INFO-TECH CITROËN Racing C3R5 19-13
Sujet : Platine volant (904615588A)

Subject : Steering wheel panel (904615588A)

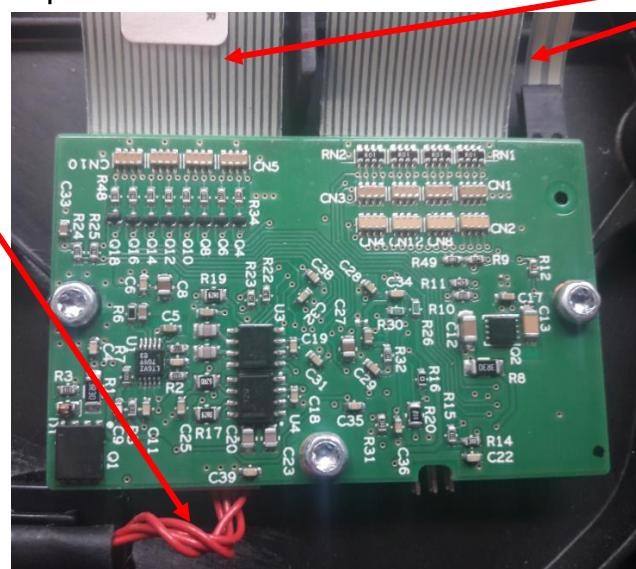
Suite à de récents cas de desserrage des vis de maintien du circuit imprimé se trouvant à l'intérieur de la platine volant (ce qui peut entraîner des dysfonctionnements de cette dernière), nous vous recommandons de coller les 3 vis de maintien à l'aide de CAF.

Attention lors de la manipulation du circuit imprimé à ne pas endommager les nappes ou le faisceau volant au niveau du petit connecteur blanc.

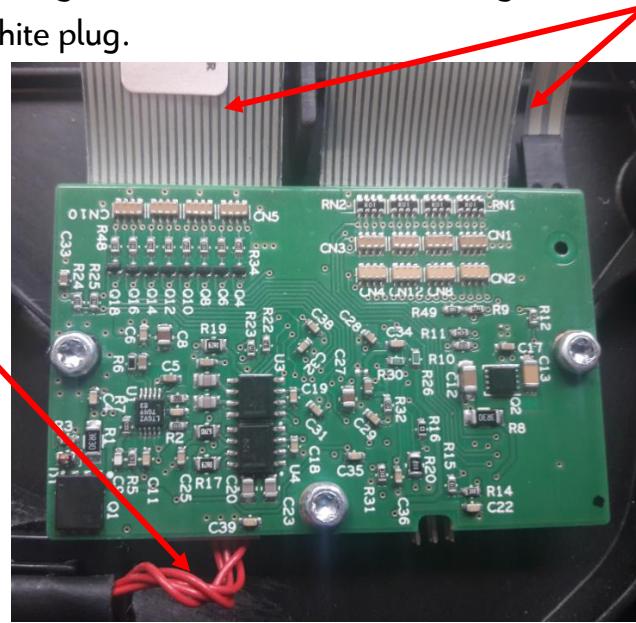
Following some recent loosening of the screws maintaining the circuit board in the steering wheel panel (thus can lead to malfunctioning), we advise you to use some silicone paste on all 3 screws as picture below.

Be carefull when manipulating the circuit board not to damage the ribbons or the steering wheel loom close to the small white plug.
